Access Compliance Report Public Rights-of-Way (Curb Ramps)

Main Street: REDBERRY_RD Cross Street: RANCHWOOD_RD Location: NE

ADA ID: RPRK220103122901 Ramp Type: Type 1 - Perpendicular Diagonal Initial Pass/Fail: Pass Overall Compliance: No Severity Score: 2

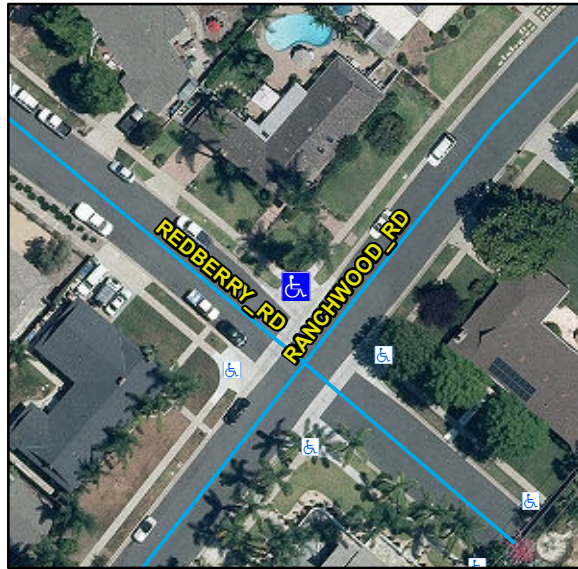
R304.2.2, R304.2.1, STD 1115

Remove & Replace Curb Ramp With Two New Directional Ramps or Equivalent.
